APPLICATION NO.	FILING DATE	FIRST NAMED INVENTOR	ATTORNEY DOCKET NO.	CONFIRMATION NO.
10/796,704	03/09/2004	Toru Takayama	10873.1414US01	2943
23552 75	7590 02/28/2006		EXAMINER	
MERCHANT & GOULD PC P.O. BOX 2903 MINNEAPOLIS, MN 55402-0903			FLORES RUI	Z, DELMA R
			ART UNIT	PAPER NUMBER
			2828

Application No.	Applicant(s)		
		TAKAYAMA, TORU		
Office Action Summary	10/796,704			
omec Action Cummary	Examiner	Art Unit		
The MAILING DATE of this communication ar	Delma R. Flores Ruiz	th the correspondence address		
The MAILING DATE of this communication appears on the cover sheet with the correspondence address Period for Reply				
A SHORTENED STATUTORY PERIOD FOR REPL WHICHEVER IS LONGER, FROM THE MAILING [Or Extensions of time may be available under the provisions of 37 CFR 1. after SIX (6) MONTHS from the mailing date of this communication. If NO period for reply is specified above, the maximum statutory period. Failure to reply within the set or extended period for reply will, by stature to reply received by the Office later than three months after the mailing earned patent term adjustment. See 37 CFR 1.704(b).	DATE OF THIS COMMUNIC 136(a). In no event, however, may a relative to

F I G. 1

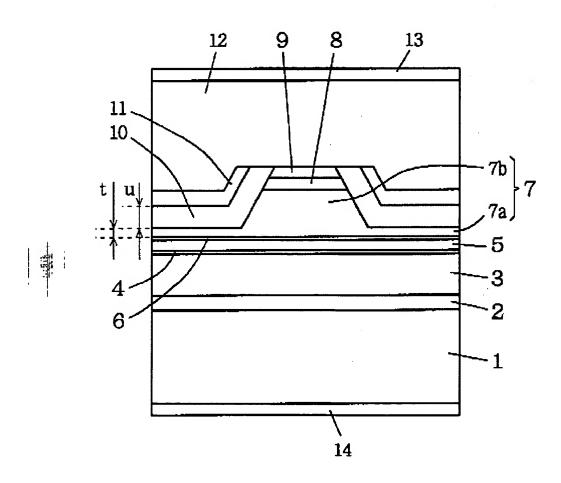
Regarding claim 1, Hiroyama discloses in Figure 1 and 8, a semiconductor laser device formed on a tilted substrate (1, Column 8, Lines 50 – 55) composed of a

compound semiconductor, comprising an active layer (5) and two cladding layers (3 and 7) interposing the active layer (5) therebetween, wherein one of the cladding layers (7) forms a mesa-shaped ridge, the ridge includes a first region (7a) where a width of a bottom portion of the ridge is substantially constant, and a second region (7b) where the width of the bottom portion of the ridge is varied continuously (Column 9, Lines 10 – 18), and the second region (7b) is placed between the first region and an end face in an optical path.

Hiroyama shown Figure 1.

Regarding claim 2, Hiroyama discloses in Figures 1 and 8, the width of the bottom portion of the ridge in the second region (7b) is increased with distance from the first region (see Fig. 1, Character 7a).

Regarding claim 3, Hiroyama discloses in Figures 1 and 8, the second region (7b) is placed between the first region (7a) and one end face in the optical path, and between the first region (7a) and the other end face in the optical path (Figure 1 and 8).

Regarding claims 4 and 5, Hiroyama discloses in Figures 1 and 8, the width of the bottom portion of the ridge in the first region (7a) and second region (7b) is in a range of 1.8  $\mu$ m to 3  $\mu$ m (Column 9, Lines 16 – 18).

FIG.6

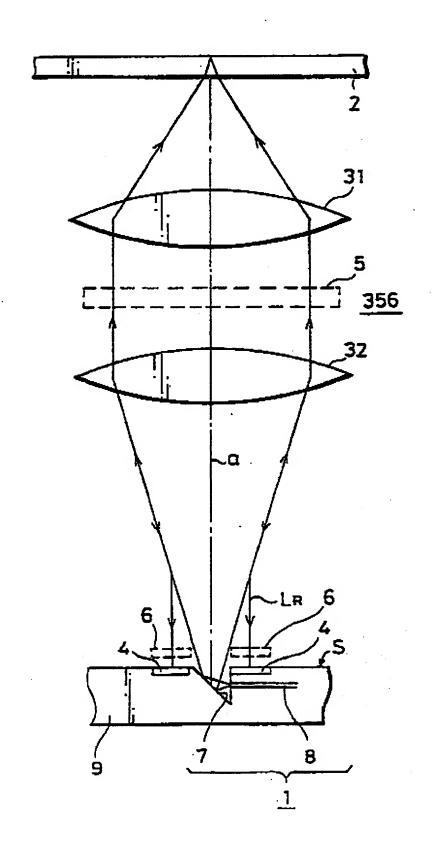
Regarding claim 10, Doi discloses in Figure 6 and 7A-12C, an optical pickup apparatus (Abstract), comprising a semiconductor laser (see Fig. 6, Character 8) device and a light-receiving portion (see Fig. 6, Character 4) for receiving light output from the semiconductor laser device (see Fig. 6, Character 8) and reflected (see Fig. 6, Character 7) from a recording medium (see Fig. 6, Character 2), wherein the semiconductor laser device (see Fig. 6, Character 8 or see Fig. 7A – 12C) is formed on a tilted substrate (see Fig. 6, Character 9, Column 6, Lines 26 – 28) composed of a compound semiconductor, and includes an active layer (see Fig. 12C, Character 23) and two cladding layers (see Fig. 12C Characters 22 and 24) interposing the active layer (see Fig. 12C Character 23) therebetween, one of the cladding layers forms a mesa-shaped ridge (see Fig. 12C, Character 24), the ridge includes a first region where

Regarding claim 11, Doi discloses in Figure 6, a light-splitting portion for splitting the reflected light, wherein the light-receiving portion receives the reflected light split by the light-splitting portion (Column 11, Lines 30 – 36 and Column 12, Lines 1 – 12).

Regarding claim 12, Doi discloses in Figure 6, the semiconductor laser (see Fig. 6, Character 8) device and the light-receiving portion (see Fig. 6, Character 4) are formed on the same substrate (see Fig. 6, Character 9).

Character 7), wherein the optical element reflects light output from the semiconductor laser device (see Fig. 6, Character 8) in a direction normal to a principal plane of the substrate (see Fig. 6, Character 9).

Regarding claim 14, Doi discloses in Figure 6, the optical element is a reflection mirror (see Fig. 6, Character 7).
